Re: **RESPONSES TO FIRST REVIEW – ILIFF STATION MULTI-FAMILY SITE PLAN MINOR AMENDMENT**
CASE NUMBER: 2015-4005-02

Enclosed herein is the second submittal for the Iliff Station Multi-Family Site Plan Minor Amendment. The comments that were provided February 13, 2018 have been addressed and are included with this letter.

SITE PLAN - SUBMITTAL
AURORA, COLORADO

3 TYPICAL BANNERS - REFER TO SHEET C-2 AND ARCH FOR LOCATIONS

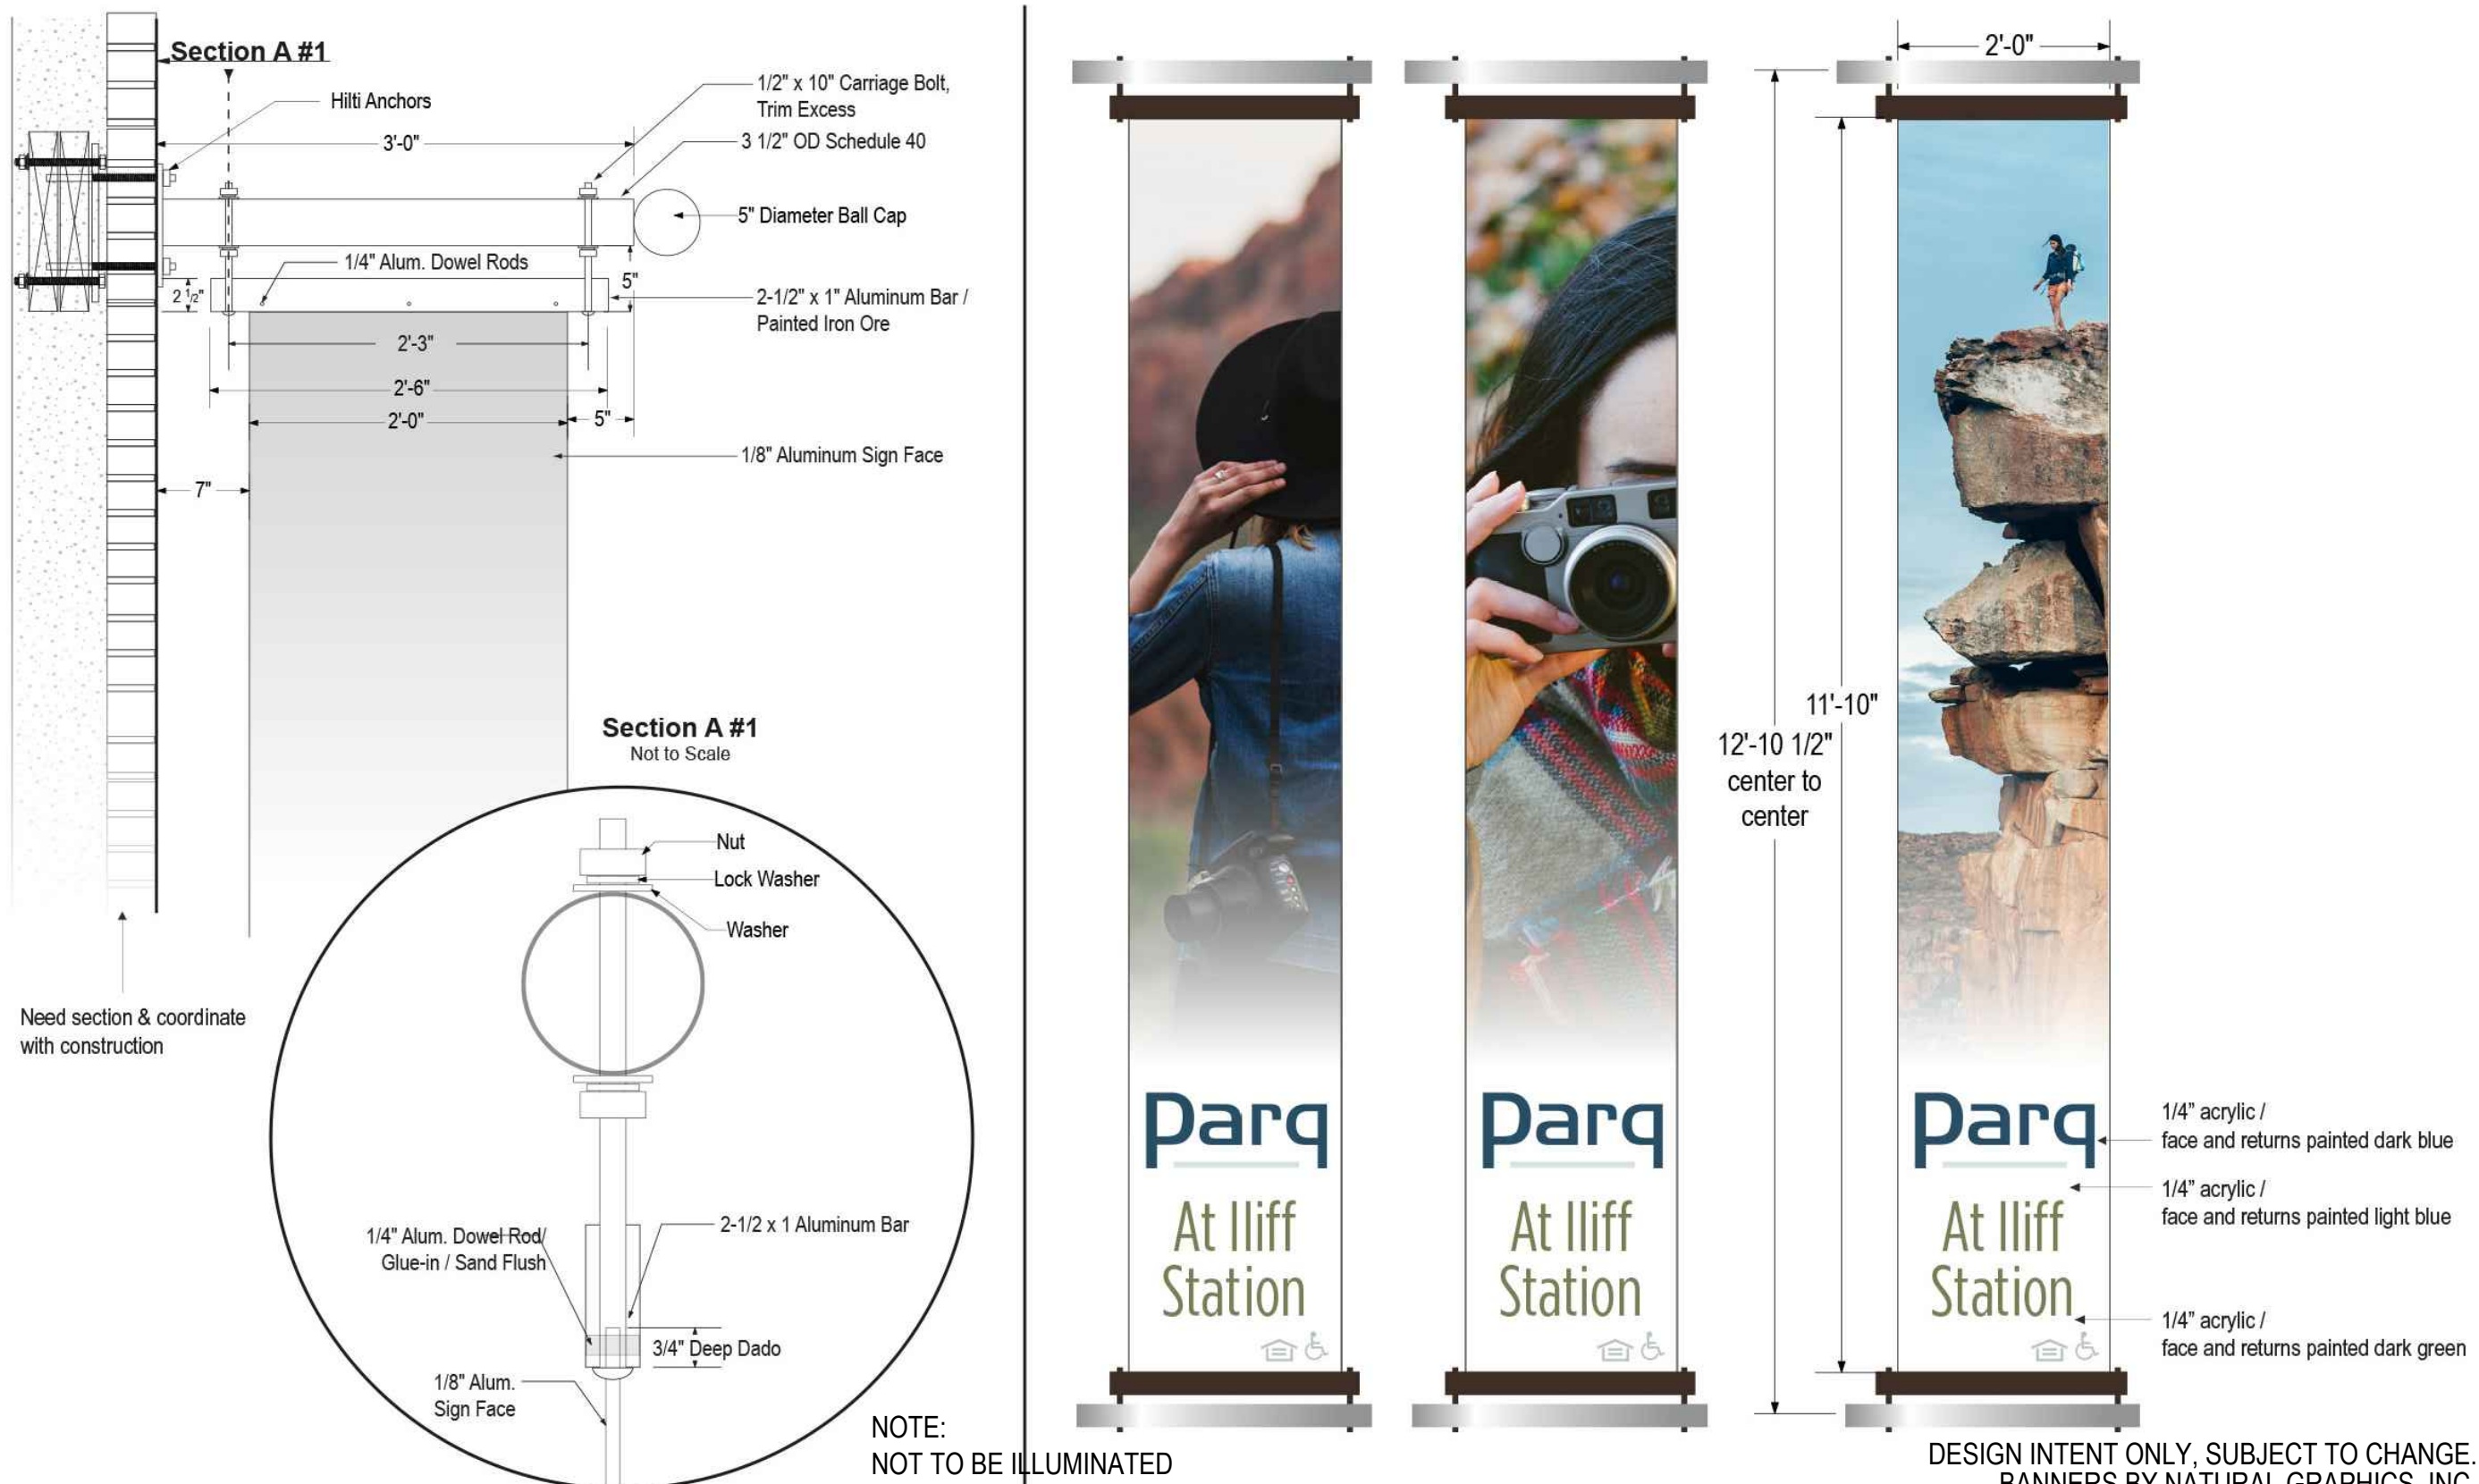
- Please refer to the "banner signs" as "Projecting Signs" per zoning code definitions. Ensure this is consistent on all sheets.

Please refer to
these as Projecting
Signs. Ensure this
is consistent on all
sheets

Response: This title has been revised.

Title has been revised

DESCRIPTION: BUILDING P, R - ELEVATIONS (STYLE B)

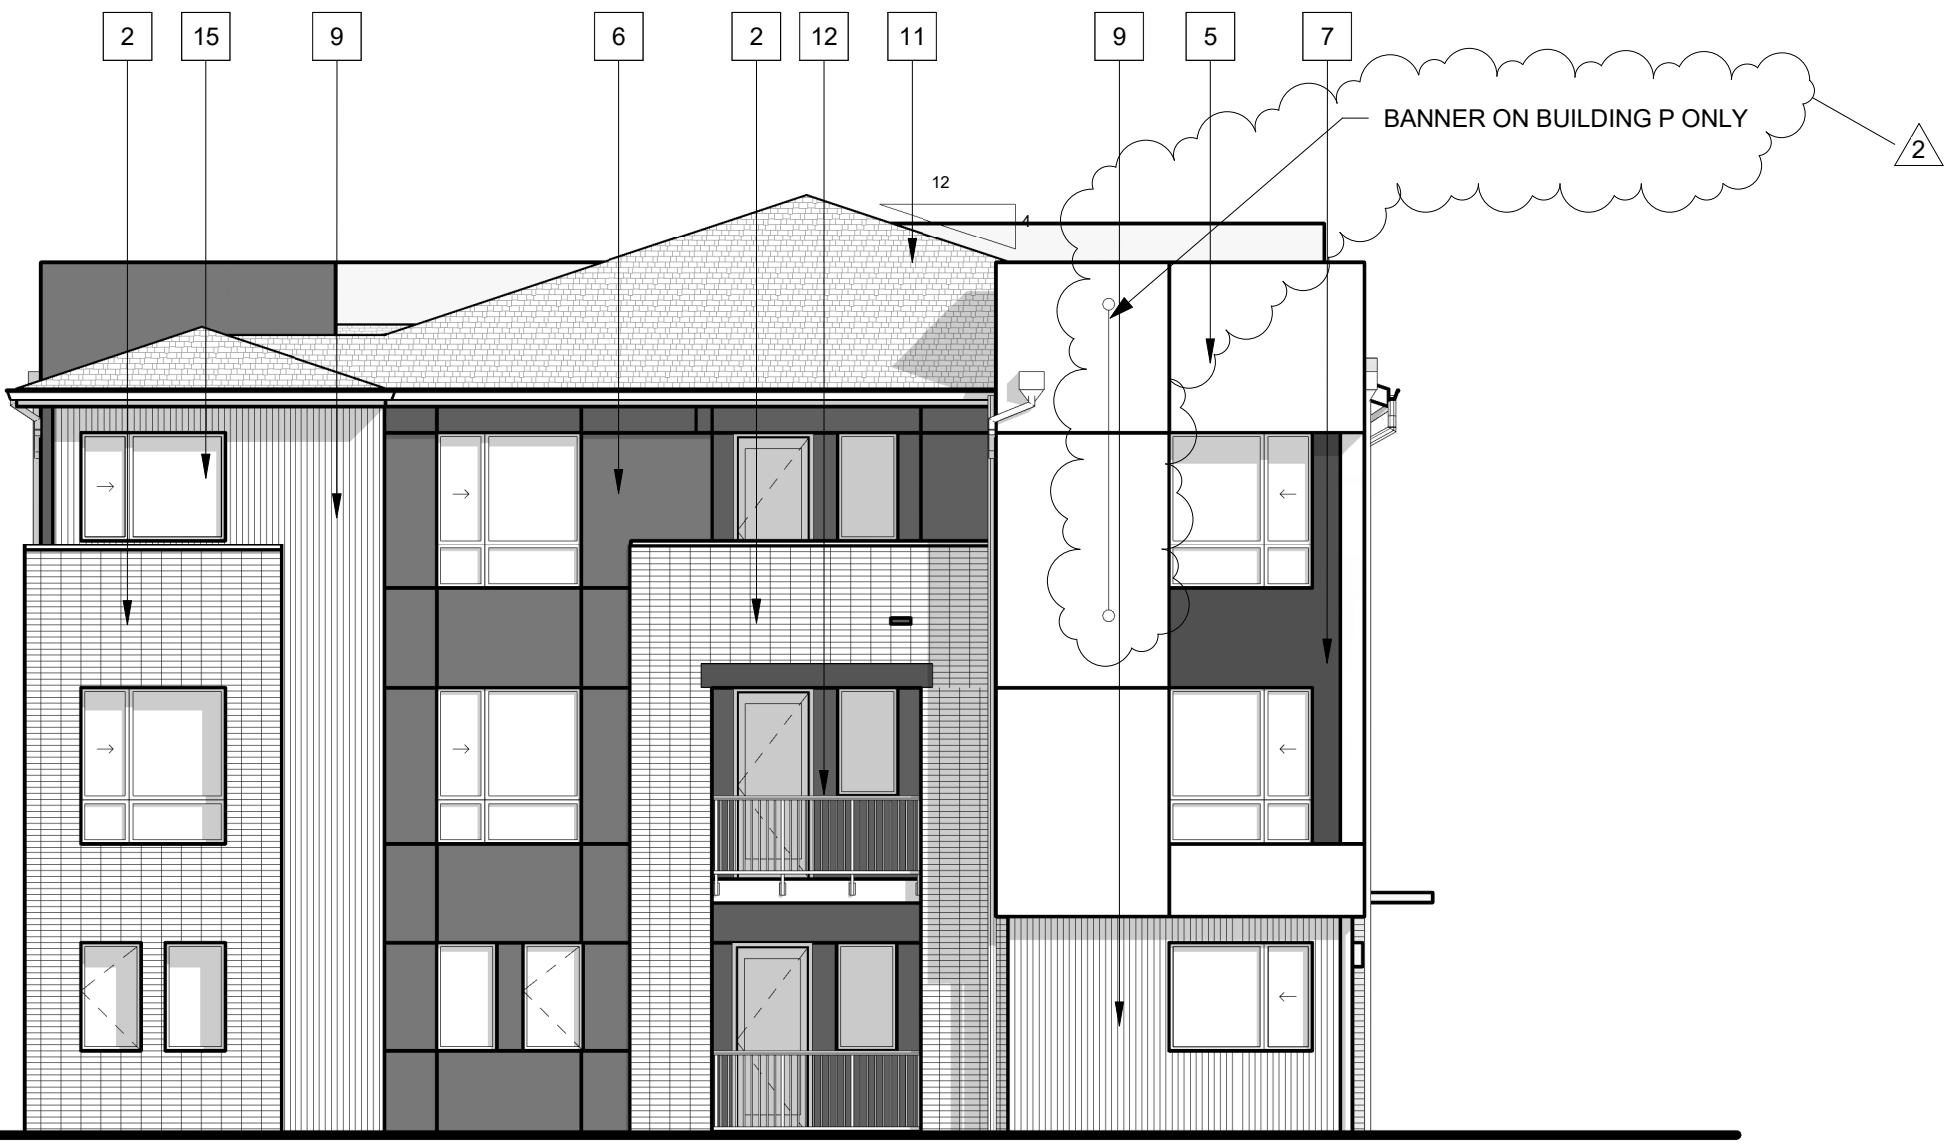
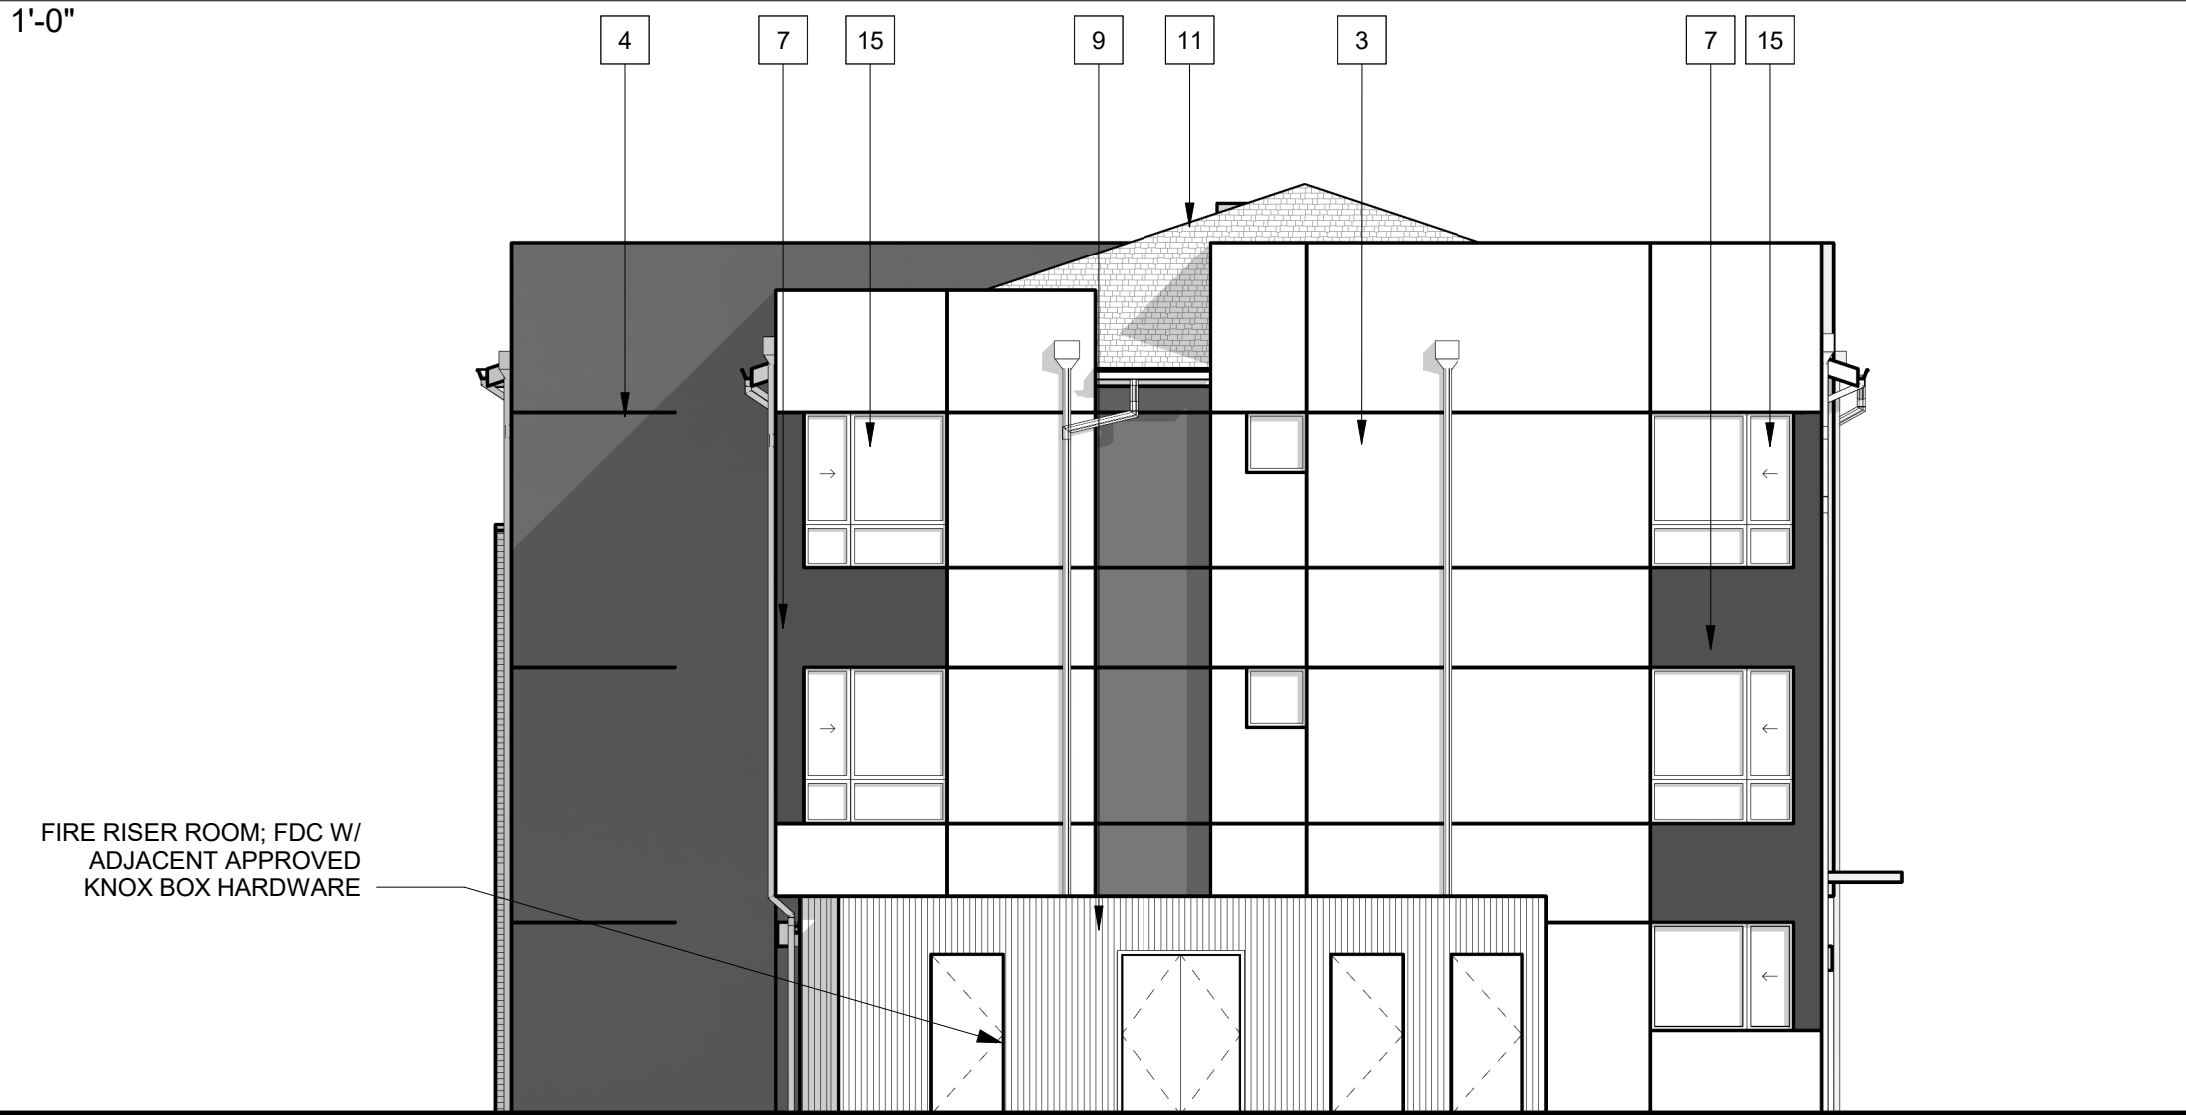
- Please correctly label what are shown as banner signs as "Projecting Signs". Ensure this is consistent on all sheets.

- Please label the clearance from the ground for all Projecting Signs.

please refer to
these as Projecting
signs. Ensure
consistency on all
sheets

please label
clearance from
ground

Response: Labels have been revised.

Response: The clearance has been added.

Labels have been added

Labels have been added
